**CAPE FARM 1552 DUYNEFONTEIN: KOEBERG NUCLEAR POWER STATION PROPOSED HARDENED WATER RESERVOIR AND ASSOCIATED PIPING – DRAFT BASIC ASSESSMENT REPORT**  
**[City Reference: B21/1/2/2/13S]**  
**[DEA Reference: 14/12/16/3/3/1/1759]**

**COMMENT ON THE DRAFT BASIC ASSESSMENT REPORT FOR THE PROPOSED DEVELOPMENT OF A HARDENED WATER SUPPLY SYSTEM (TWO RESERVOIRS) AND ASSOCIATED PIPING AT THE KOEBERG NUCLEAR POWER STATION LOCATED ON THE FARM DUYNEFONTYN NO. 1552, MELKBOSSTRAND (DEA REF: 14/12/16/3/3/1/1759)**

### **COMMENTS ON THE DRAFT BASIC ASSESSMENT REPORT FOR THE PROPOSED HARDENED WATER RESERVOIR AND ASSOCIATED PIPING AT THE KOEBERG NUCLEAR POWER STATION LOCATED ON THE FARM DUYNEFONTYN NO. 1552, MELKBOSSTRAND, WESTERN CAPE PROVINCE.**

FIGURE 1

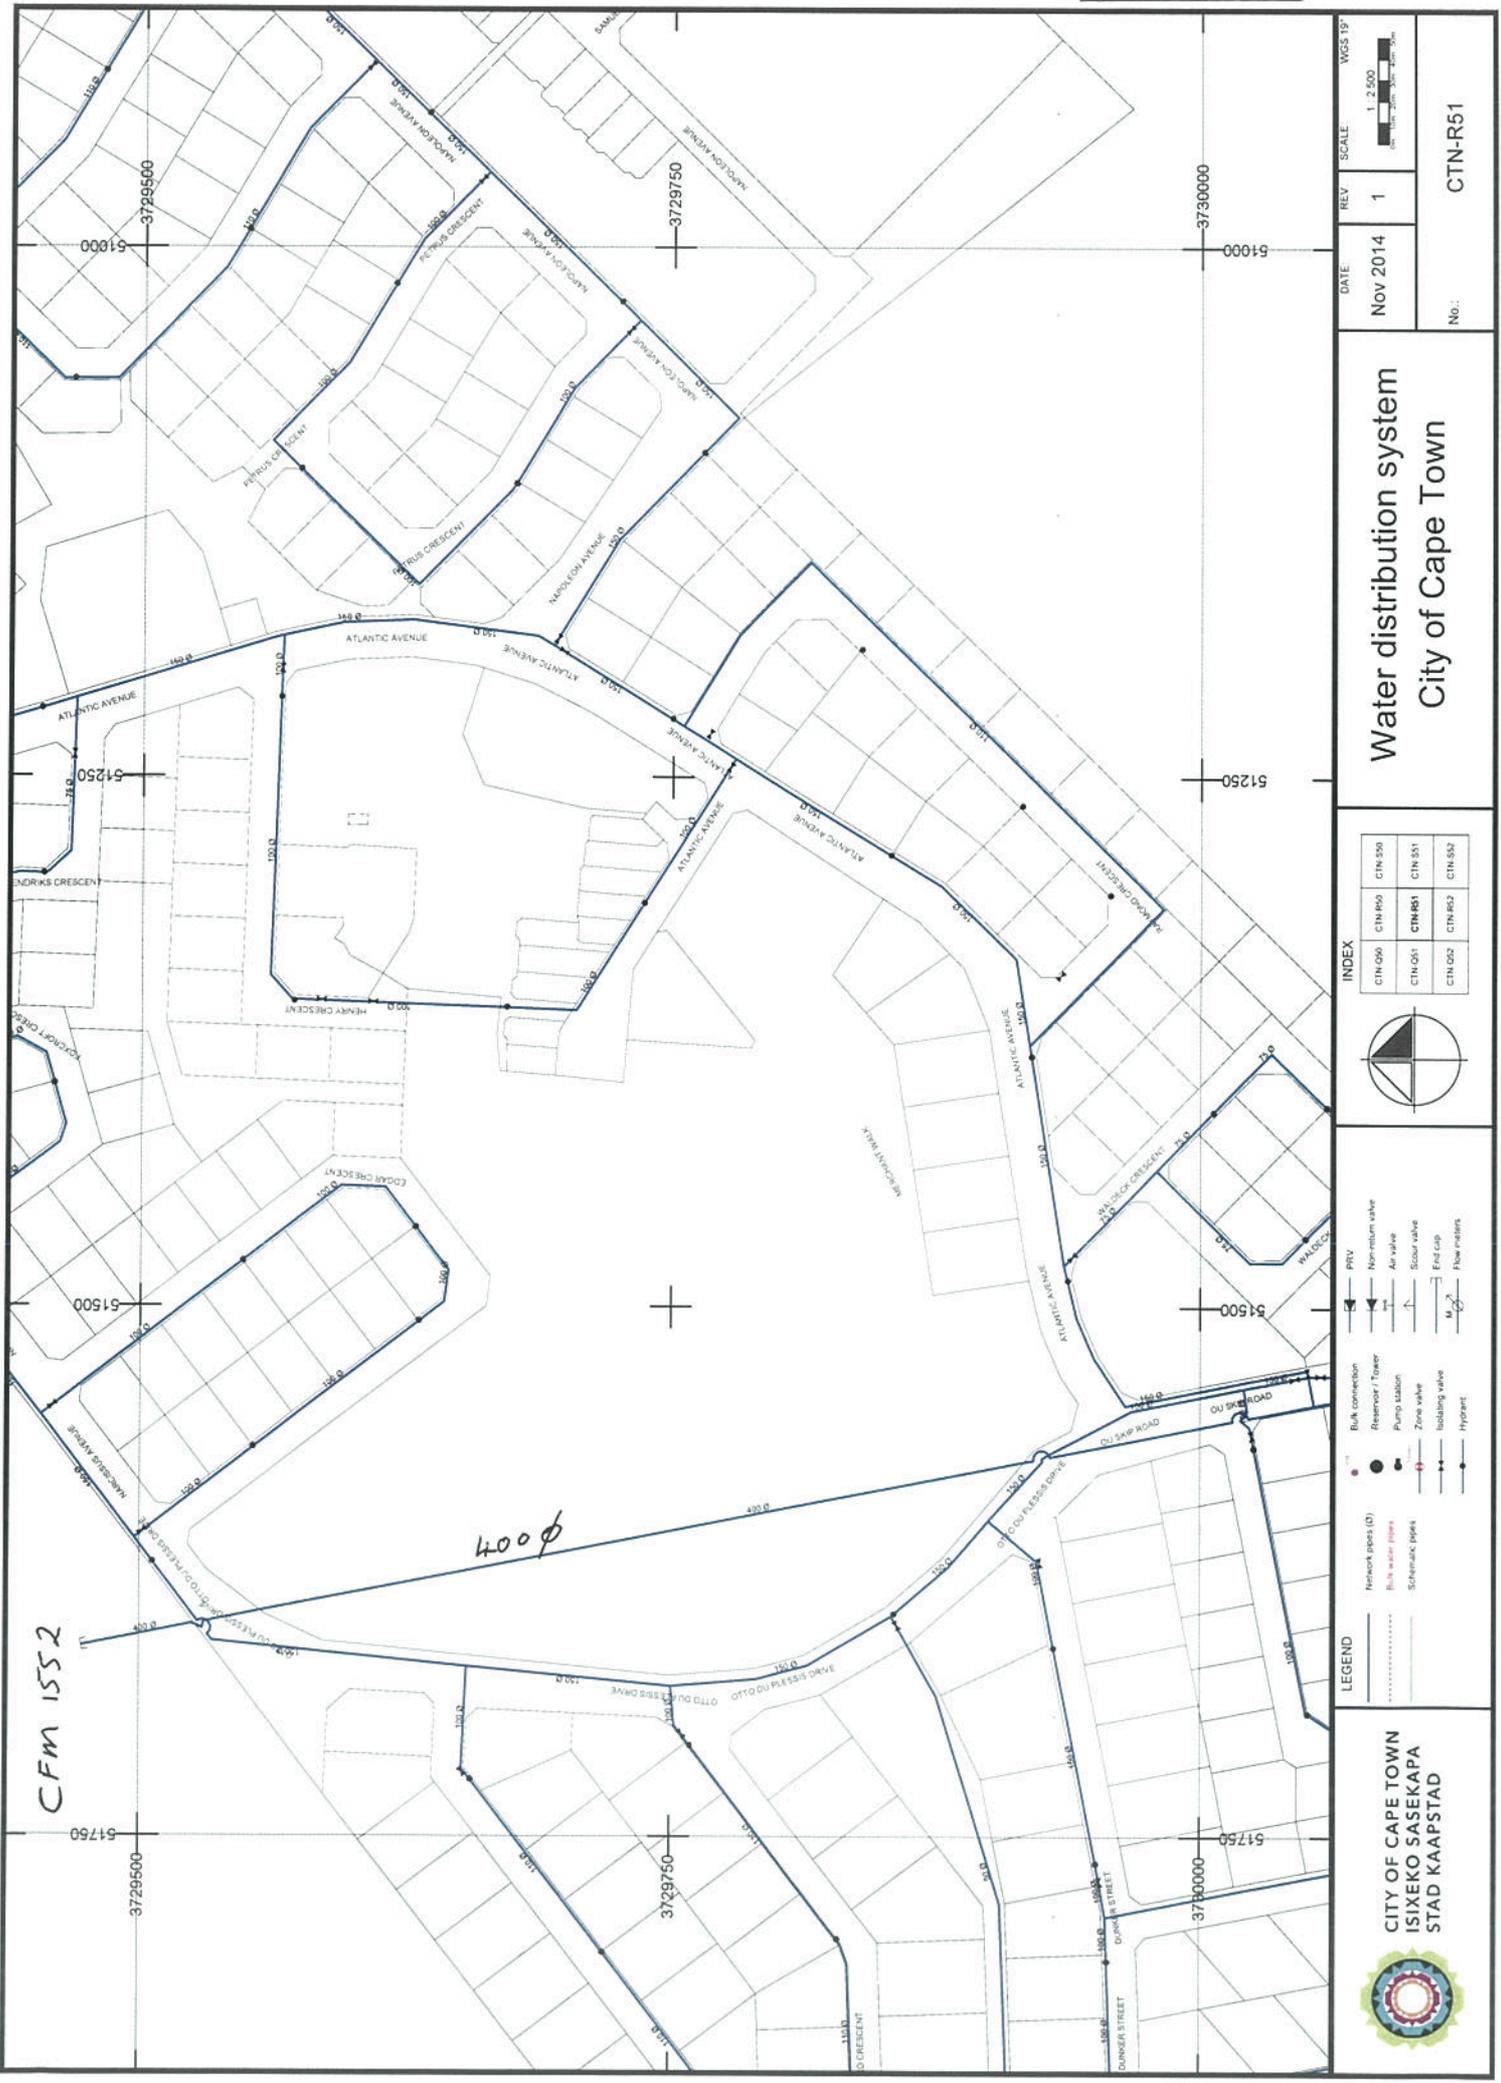
There is water supply to the southern boundary of the Cape Farm 1552 by means of the existing 400mm water supply located off Otto du Plessis Street (refer to the Water Distribution system plan, Drawing No: CTN-R51, attached Figure 1).

The peak pressure in the 400mm water main is about 74m. The 400mm supply is capable of delivering 144 l/s maximum. In practice this means it will take about 18,5 hrs to fill the reservoir.
